The Planning Application to repair the funicular (2)

Highlands and Islands Enterprises (HIE) are at it again as evidenced by the latest planning application, to repair the funicular ([see here for papers](#)).

Site Location Plan

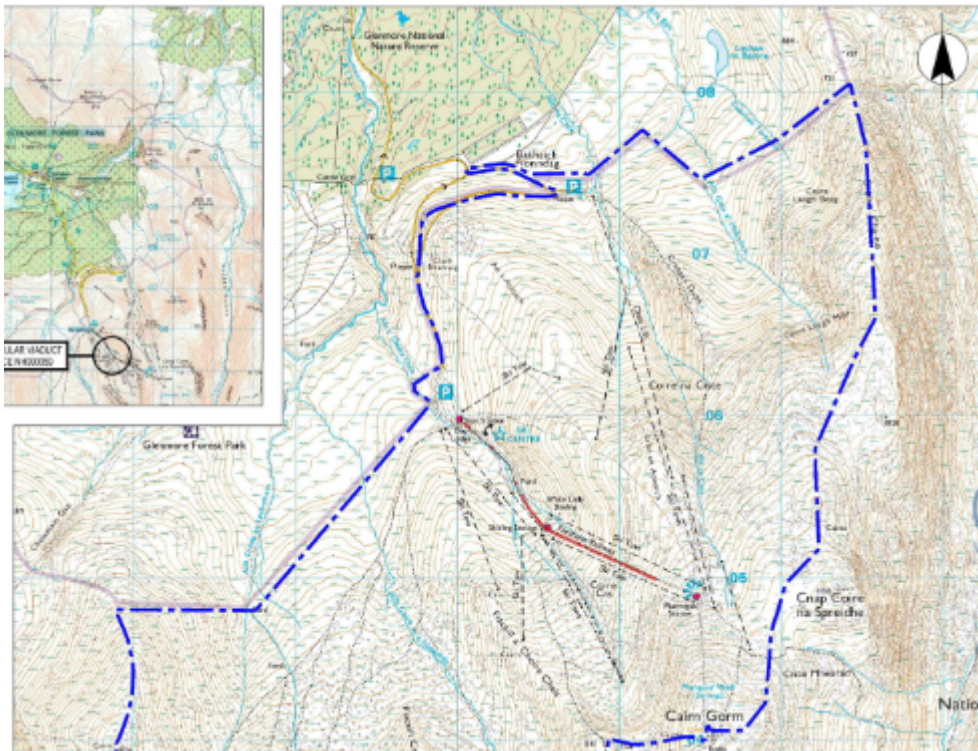
Cropped map courtesy of CNPA Planning Portal showing lifts in Coire na Ciste and the development area in red. This is not actually

a line but a series of blocks around each pier (see below)

As the name implies this document shows the area of Cairn Gorm under the control of HIE, the blue line is its border, which you would expect to be an up-to-date overall view of the area including skiing infrastructure. Yet it shows tows and lifts that no longer exist! It gives the impression that there is a lot more uplift than is actually available.

Application Site Boundary (Paras 2.4, 2.5 and 2.6)

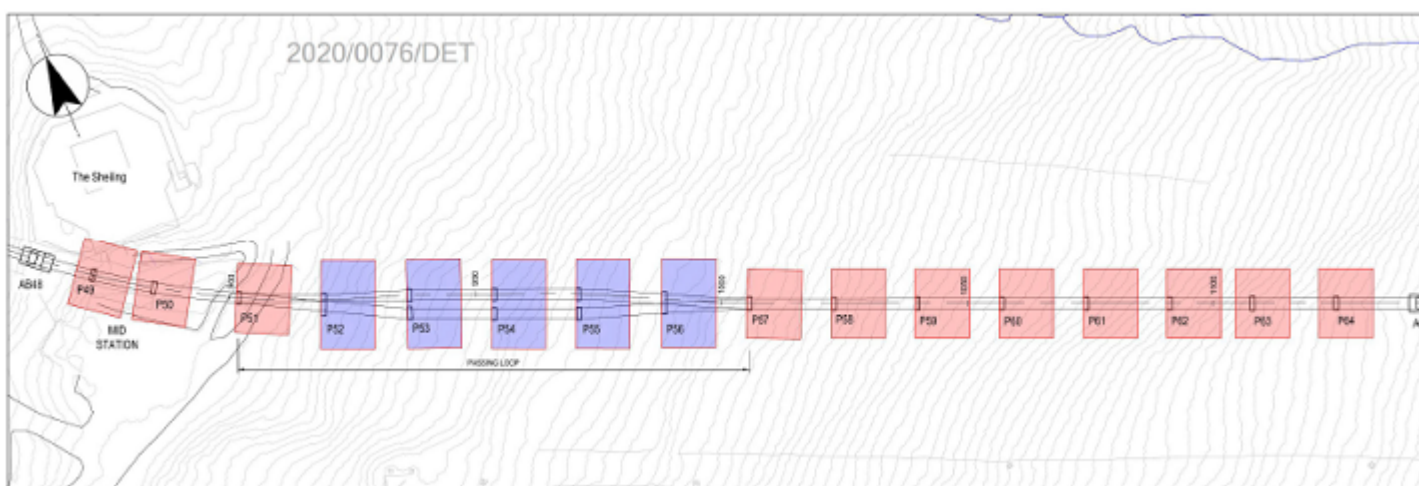
Extract from site boundary, mid station on left. The pink and blue demarcate the area included in the planning application.

Instead of showing the entire working area, with access tracks etc, HIE have only included in the application the areas around the piers supporting the funicular.

This is highly unusual, indeed wrong, as usually the entire working area is included in a Planning Application, as happened with the Shieling Rope Tow. It appears HIE has done this to reduce planning fees as the larger the site, the larger the planning fee.

Even so, HIE have misrepresented the size of the area. I have counted and the plans show 55 piers, and 2 anchor blocks (AB14 & AB29), marked in pink, total 57, and, 5 piers which are part of the passing loop marked in blue (see above). That is a total of 62 rectangular areas, 60 piers and 2 anchor blocks. Yet Para.2.5 states that there are 65 rectangular areas, 60 piers and 5 anchor blocks, so apart from the two shown on the plans, AB14 and AB29, what size are the work areas for the other three missing anchor blocks and which ones are they out of AB 0, 48, 65 and 78?

The pink areas are $11\text{m} \times 14\text{m} = 154\text{sq.m}$. Pink areas = 8,778sq.m.

The blue areas are $11\text{m} \times 18\text{m} = 198\text{sq.m}$. Blue areas = 990sq.m.

Total area = 9,768 sq.m.

If three anchor block work areas have been missed off the plans, their combined area will be 462 sq.m. (154×3) and will bring the total work area to 10,230 sq.m.!
